e-HIGHWAY 2050			
Modular Development Plan of the Pan-European Transmission System 2050			
Contract number	308908	Instrument	Collaborative Project
Start date	1st of September 2012	Duration	40 months
WP 1	**Setting the Boundary Conditions for 2020-2050 grid planning**		
	Feedback from WP1 workshop 23 January 2013

This memo contains a summary of feedback received after the e-HIGHWAY2050 stakeholder workshop in Brussels 23 January, with comments from the consortium.

Figure 1: lists of options and uncertainties for generation technologies

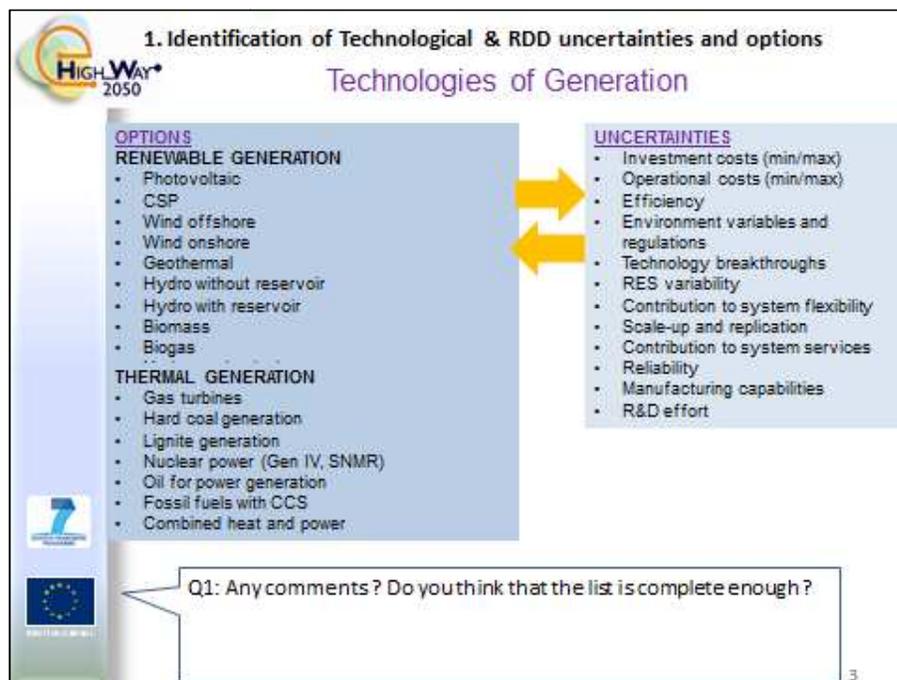
- **CECED**: Micro energy generators or co-generators could enable a true smart grid that manages consumption/demand locally.
  - ✓ **e-Highway2050**: CHP is considered as part of the generation mix in the Scenario definition part, but the heat distribution is not specifically included in the market and grid analyses. The ratio of CHP plants to pure electricity generation plants

- **COGEN Europe**: CHP could make a bridge between fossil fuels and RES (in thermal plant).

- **ELIA**: Should wave energy or ocean thermal energy conversion be added?

- **ENSIEL**: Electricity generation from waste combustion should be included.

- **ENTSO-E**: Will life cycle assessments (LCA) be performed?

- **RTE**: Is there any possibility for large diffusion of micro-CHP in the household sector?

- **SIEMENS**: Will electric imports from outside Europe and sustainability of new technologies be considered?

- **VGB Powertech**: Marine (tidal, wave, OTEC), nuclear (small modular reactors) should be considered. Add "Load factor" as uncertainty.

depends on the competitiveness of each technology considered. In the Scenario Development work, a certain electricity to heat generation ratio will be considered. However different ratios will be used for different technologies.

- ✓ **e-Highway2050**: CHP is considered as part of the generation mix.

- ✓ **e-Highway2050**: Marine technologies (wave, tidal, OTEC) should be included in the analyses.

- ✓ **e-Highway2050**: it is included as part of biomass generation.

- ✓ **e-Highway2050**: LCA is currently not part of the analyses. However, typical variables such as CO_2 footprint, energy pay-back time, etc., will be taken into account, if available, in the data gathered in WP3 for each technology.

- ✓ **e-Highway2050**: Micro generation can be considered as a sub-technology of different technologies such as gas turbines, CHP, etc. At the local consumption level, their contribution will be included in the demand calculations.

- ✓ **e-Highway2050**: Electricity exchanges at European borders are one of the main factors in scenarios (Generation/Demand/Exchange profiles); however sustainability of specific technologies (LCA) is not explicitly included (cf. question above raised by ENTSO-E).

- ✓ **e-Highway2050**: Ocean energy and small nuclear will be included in the analysis. Possible load factors (for generation units) will be a result of the analyses.

Figure 2: List of uncertainties and options for storage technologies.

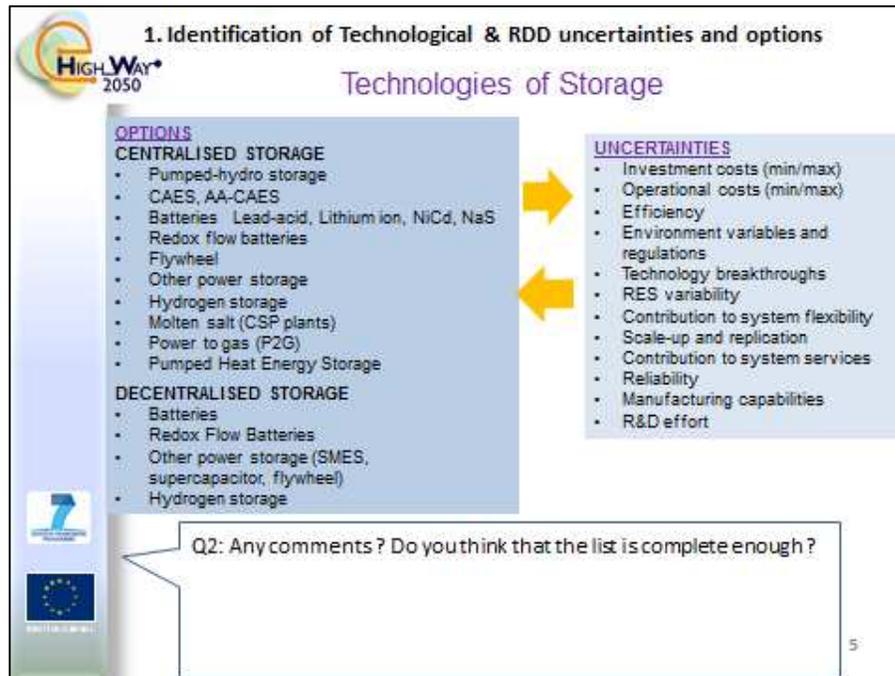
- **COGEN Europe**: Electricity storage at decentralized level in a **thermal (heat-steam)** form should be considered.

- **EASE**: It is recommended to segment Storage as **Bulk storage**, **Grid storage** and **End user storage.**

- **ELIA**: Centralized storage should include **Compressed air energy storage**? Decentralized storage should include **Parked and plugged-in electric vehicles (EVs)**?

- **ENSIEL**: **Vehicles to grid (V2G)** should be included. **Sea pumping** should be coordinated with offshore wind.

- **EURELECTRIC:** Uncertainties are correlated to each other

- **RTE**: Add "**vehicles to grid**" and "**heat storage**" (for example, hot water storage combined with a heat pump to perform peak shaving)

- ✓ **e-Highway2050**: Thermal storage is currently only considered as centralized storage.

- ✓ **e-Highway2050**: The consortium has decided to keep the current classification

- ✓ **e-Highway2050**: CAES (both current and future technologies) is included in e-Highway2050 analysis. EVs are considered under demand technologies including vehicle to grid applications.

- ✓ **e-Highway2050**: EVs are considered under demand, not as a specific storage option. Pumped hydro is included with salt water as an option when geologically feasible.

- ✓ **e-Highway2050**: Yes, absolutely, and this will be further elaborated as the project scenarios are built.

✓ **e-Highway2050**: EV's, heat pumps and peak shaving are considered under demand-side technologies.

Figure 3: List of options and uncertainties for demand-side technologies

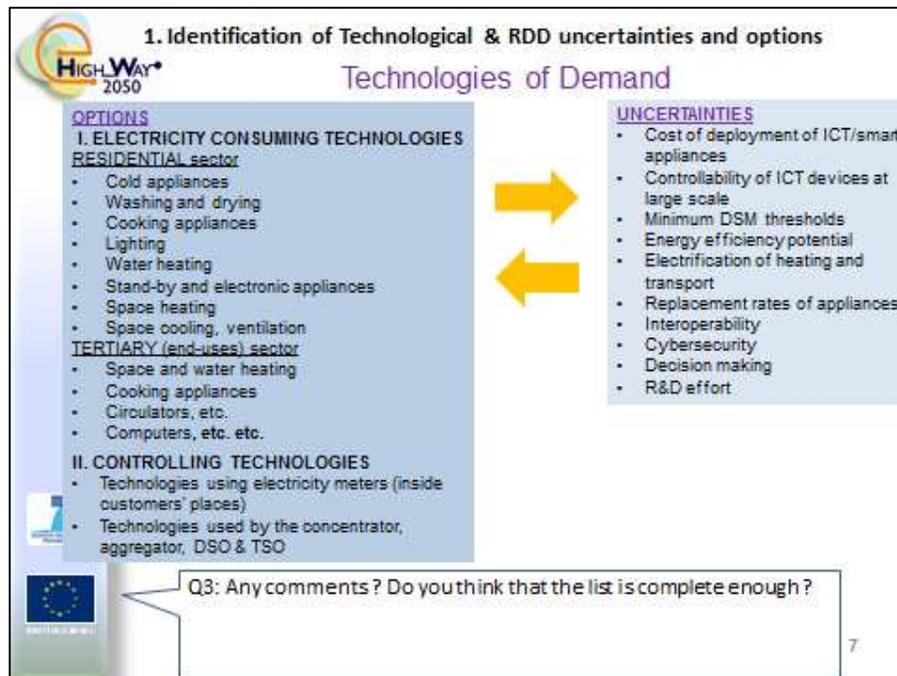
- **CECED:** The possible massive introduction of **electric vehicles** should be considered

- **ELIA**: Is **Heat pump** assumed as part of heating&cooling?

- **ENSIEL**: **Electric transportation** should have more emphasis

- **EURELECTRIC:** Political decisions might drive uneconomic developments (e.g. smart meter) which being in place might accelerate beneficial services in other sectors.

- **RTE**: Technologies that could have a dramatic impact on demand should be considered: **Electric vehicles or heat pumps**.

- **SIEMENS:** The electrical **exports** outside Europe should be considered.

- **VGB Powertech**: Add "**Temperature Control Devices**" as an option.

✓ **e-Highway2050**: Yes, it is considered under demand.

✓ **e-Highway2050**: The effect of heat pumps is considered under demand calculations.

✓ **e-Highway2050**: Yes, it is considered under demand.

✓ **e-Highway2050**: Yes, such dependencies will be more elaborated as e-Highway2050 scenarios are built.

✓ **e-Highway2050**: Yes, they are considered under demand.

✓ **e-Highway2050**: Electricity **exchange** outside Europe (including both import and export) is a main factor in (G/D/E) scenarios.

✓ **e-Highway2050**: Yes, they will be considered under the sub-category renamed "Technologies AFTER electricity meters".

Figure 4: list of options and uncertainties for passive and active transmission technologies.

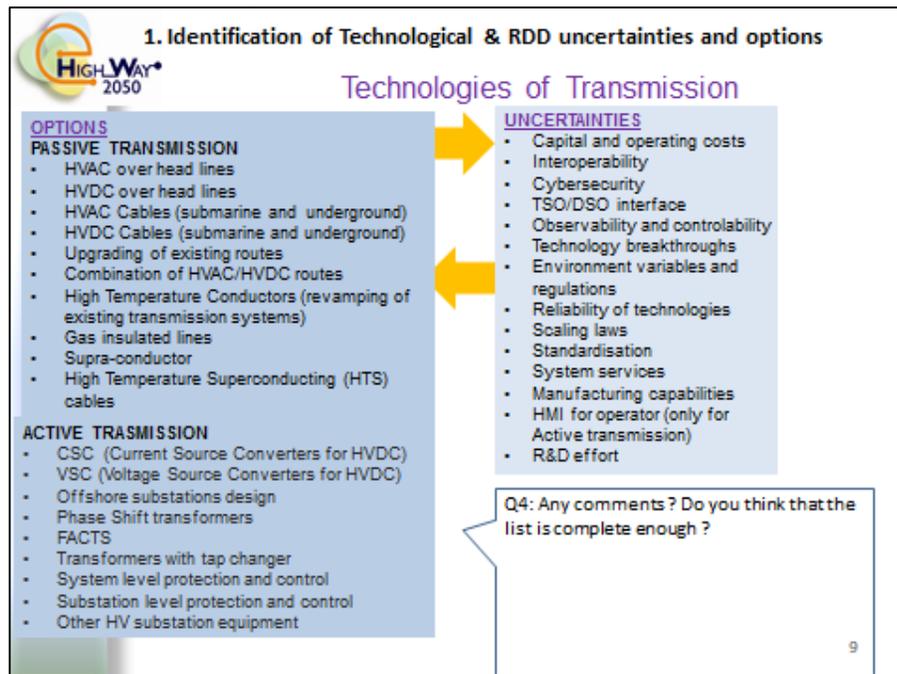
- **ENSIEL**: **Meshed DC grids** and **Electronic Transformers** should be added in the Options. In the Uncertainties, **bulk power system controllability** should be added.

- **ENTSO-E:** What about **multi terminal converters** for installing a meshed HVDC-Grid?

- **EURELECTRIC:** Increased capacity of lines by **temperature monitoring** should be considered**.**

- **Europacable**: The **combination of overhead lines and cables** (in AC and DC systems) should be treated as an active transmission technology

- **SIEMENS: Automatic European TSO** as Option

- **VGB Powertech**: "**FACTS, SVC, etc.**" should be added as an Active Transmission option.

✓ **e-Highway2050**: Meshed DC grids are not as such a key technology. It depends on the development of other technologies, such as VSC, DC breakers, etc., which are considered in the above list. Bulk power system controllability will be added as uncertainty.

✓ **e-Highway2050**: Yes, key technologies like CSC or VSC converters, DC breakers, etc., are considered.

✓ **e-Highway2050**: This is more an operational option than a technology. RTTR will be considered in OPEX driven technologies.

✓ **e-Highway2050**: this technology will be moved to active transmission as suggested.

✓ **e-Highway2050**: Bulk power observability and controllability are considered as uncertainties, but automatic pan-European TSO is not yet considered as an option.

✓ **e-Highway2050**: Yes, both are already considered.

Figure 6: list of economic, socio-political and environmental options and uncertainties

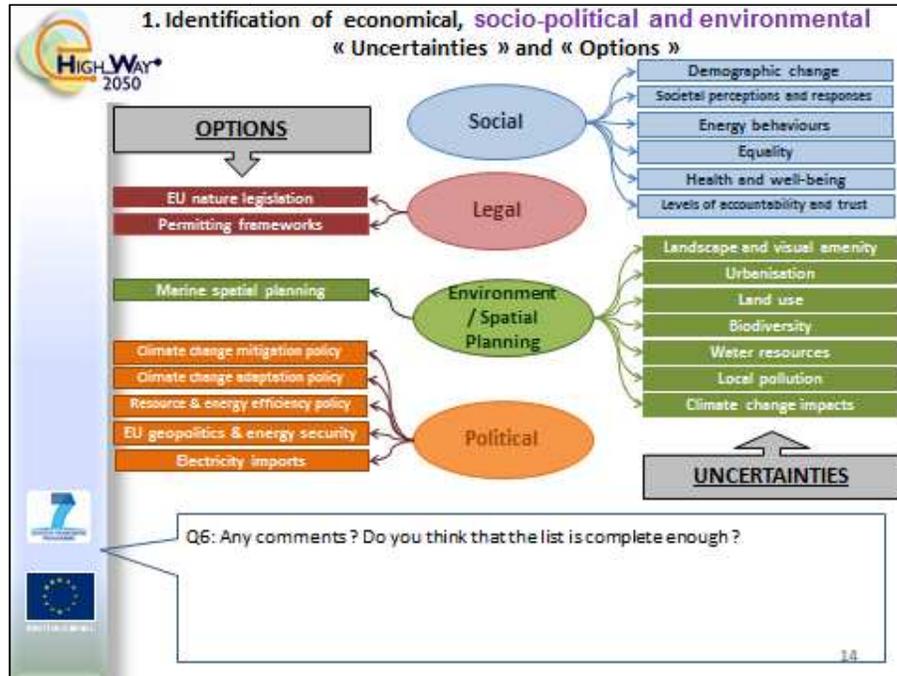
- **EASE:** Will the non-binding **2050 decarbonization aims** be regarded as an uncertainty or as a fixed assumption?
  - ✓ **e-Highway2050**: The Steering Committee has decided to treat the 2050 targets as a fixed assumption for all e-Highway2050 scenarios, with the exeption of a reference/BAU scenario which *might not* reach 80-95% GHG emissions reduction.

- **ELIA**: What about the **share of primary, secondary and tertiary sector**? Will there still be a manufacturing sector in Europe? How will work be organized? Will we all work from home or will we still commute daily by electric vehicle or public transport?
  - ✓ **e-Highway2050**: This aspect has not been directly discussed as a boundary condition; but it will be considered when building the e-Highway2050 scenarios, in WP2.

- **ENSIEL**: We should also take into account social conditions not only in the EU, but also e.g. in **northern Africa**, that can impact exports to EU.
  - ✓ **e-Highway2050**: Yes, this is partly covered both under "EU geopolitics & energy security" and "Electricity imports" options.

- **ENTSO-E:** Is «**Acceptance**» considered?
  - ✓ **e-Highway2050**: Yes, but we use the broader term "social perceptions and responses" to address this issue .

- **EURELECTRIC:** These uncertainties are **too far away from grid modeling**. I am missing **legal and political uncertainties** which turn out to be the major problem in today's framework.

- **RTE**: The potential impact of **ICT on the organization of work** should be considered.

✓ **e-Highway2050**: We are not limiting our scope to "grid modeling" but we are considering all uncertainties and options for the development of electricity highways. A broad range of legal and political uncertainties is discussed in Task 1.4.

✓ **e-Highway2050**: See comment to ELIA's question above.

Figure 7: Selection of main options and uncertainties for technologies and RDD (Research & Development and Demonstration)

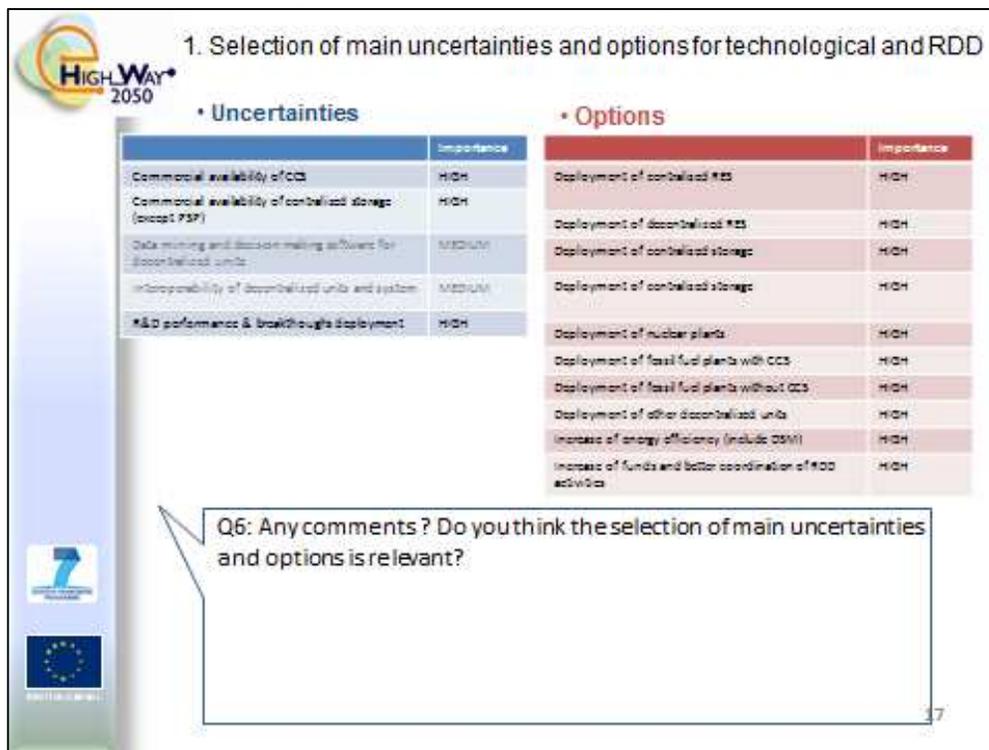
- **EASE:** The segmentation "**bulk storage, grid storage & end user storage**" should be used.

- **ELIA**: The «Increase of DSM» with **energy efficiency, load shifting and peak shaving** should be mentioned as possible outcomes.

- **ENTSO-E:** Why do you consider centralized Storage (**except PSP**)? No options are considered regarding **transmission technologies**?
  - ✓ **e-Highway2050**: EWI Köln claims in a report that no further investments than planned at present are possible for in pumped hydro storage are possible in Europe, but this does not seem to agree with ongoing discussions in e.g. Norway and the Alpine region. Options for transmission technologies and transmission expansion will be considered in main work packages of the project.

- **EURELECTRIC: Is Commercial availability of CCS** included in R&D-uncertainty?
  - ✓ **e-Highway2050**: Yes, it is considered under RD&D.

- **SIEMENS: Electrical imports** from outside Europe should be considered xith Medium importance
  - ✓ **e-Highway2050**: This is considered under Political uncertainties, but with High importance.

✓ **e-Highway2050**: See reply in previous section.

✓ **e-Highway2050**: Although this is not listed as a main option, it will be included in the scenario building.

Figure 10: Economic, socio-political and environmental Boundary conditions

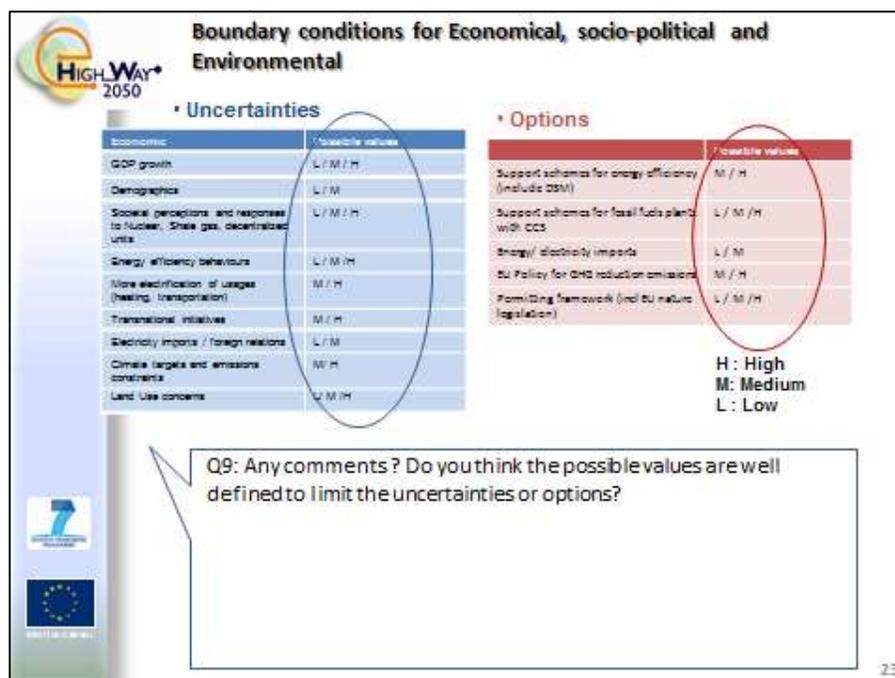
- **CEP:**
  1. **Social perception and responses** should not just focusing on nuclear energy, shale gas etc.
  2. Some other **environmental issues** (landscape/visual and biodiversity etc) are not just part of the "acceptability" issue.
  3. **EU geopolitics**, and level of integration and disintegration, is potentially a very important uncertainty.
  4. The impacts of a **changing climate** are an uncertainty we are researching further.
     - ✓ **e-Highway2050**: Since CEP is the leader for Task 1.4 Political, Socio-political and Environmental boundary conditions in e-Highway2050, these points are already taken into account.

- **COGEN Europe:**
  1. **Societal perception**: Same uncertainties hold for the building of centralized pp from local communities.
     - ✓ **e-Highway2050**: Yes, this is included in the more general "Societal perceptions" uncertainties.
  2. **EU policy for energy efficiency** should be mentioned in the first row.
     - ✓ **e-Highway2050**: See comment above
  3. Another row should be on «**EU policy in support to better siting of pp** (closer to consumption centers)».
     - ✓ **e-Highway2050**: See comment above

- **ENSIEL: Electric Transportation** should be distinguished from heating.
  - ✓ **e-Highway2050**: See comment above

- **RTE:** "**Energy prices**" should be added to main uncertainties
  - ✓ **e-Highway2050**: Yes, see "Main uncertainties" slide.

- **SIEMENS: Electrical imports** from outside Europe should be added as a political Uncertainty with Medium/Low importance.
  - ✓ **e-Highway2050**: See comment above

Figure 11: Methodology for scenarios identification

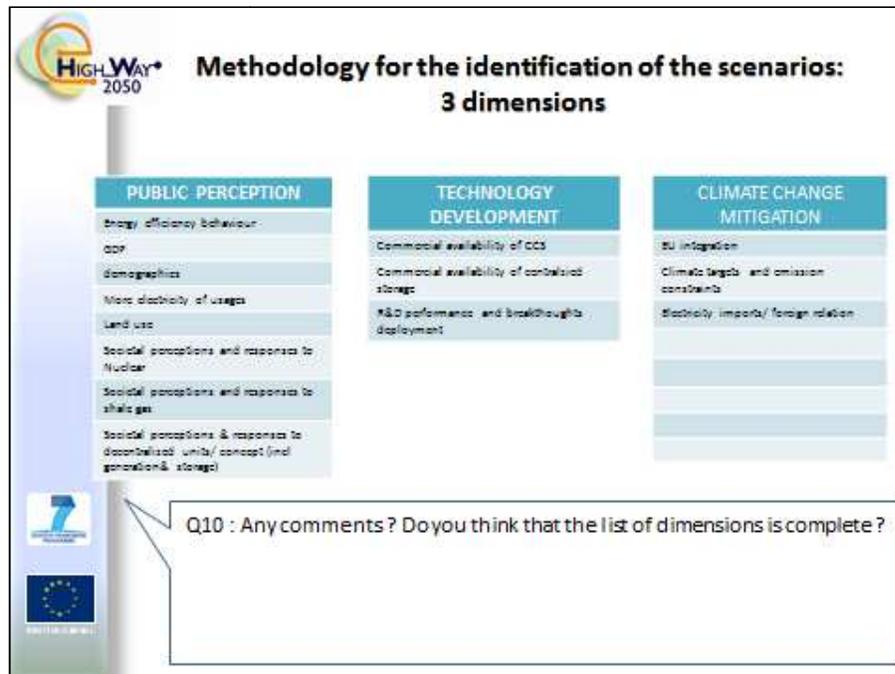
- **COGEN Europe:**
    - Climate change -> Side effects of **EU policies in the field of EE and RES**.
    - **Bioenergy** should also be listed in Public perception.

- **E3G**:
    - If we fix the EU carbon target it makes sense to remove '**international climate agreement**' as an uncertainty. Other factors (global economic growth) are perhaps better drivers of fuel price movements. *Keeping it as a core uncertainty will lead to distracting arguments about whether the EU should retain its carbon target if the rest of the world has not adopted a target of its own*.

- To enable better comparability between scenarios, I would prefer to treat some factors, such as **demographics and GDP as inputs or assumptions, rather than uncertainties.**

- An uncertainty may be '**environmental conflict blocks deployment**' vs '**environmental factors successfully managed**'.

- **ELIA**: Public perception of **grid infrastructure** remains negative? Social perceptions to **different types of production**, e.g: Coal, Onshore wind, etc

- **ENSIEL**: You should add **techniques to control storage** in order to allow more RES to be connected.

- **Europacable**: Recommendation to add "**Blackstart scenario**" as one of the uncertainties:

- **RTE**: The title "public perception" is surprising insofar as it contains items like "GDP" or "demography". We should maybe find another title ("**social and economy context**"?) The energy prices should be added.

- **ENTSO-E**: **Public Perception** and **technology development are** suitable dimensions. **Climate mitigation is** absolutely a crucial dimension; but by focusing on this one aspect is there not the risk of creating a model where some environmental aspects cannot be represented? Concretely, some important environmental aspects of the 'small things matter' scenario may be difficult to place within the created model (i.e. its system boundaries).

- **SIEMENS: Integration** between Asia, Africa, America and Australia should be considered under Climate Change Mitigation.

- ✓ **e-Highway2050**: We have already changed this structure considerably in the scenario building. Climate change is no longer defined as proxy driver. Public perception encompasses all relevant technologies.

- ✓ **e-Highway2050**: We have already changed this structure considerably in the scenario building.

- ✓ **e-Highway2050**: These issues are discussed in greater detail in Task 1.4

- ✓ **e-Highway2050**: This will be an hypothesis in "high tech" scenarios.

- ✓ **e-Highway2050**: That sounds more like a contingency for the grid feasibility study, than a scenario uncertainty itself. The blackstart capability should be tested for all scenarios.

- ✓ **e-Highway2050**: It was grouped under perception as a relevant proxy driver; but we have already changed this structure considerably in the scenario building.

- ✓ **e-Highway2050**: We have already changed this structure considerably in the scenario building.

- ✓ **e-Highway2050**: We are not sure what kind of integration you mean here. Typical variants under Climate Change Mitigation as proxy drivers would be whether there is a global agreement with global CO_2 prices or only regional agreements.
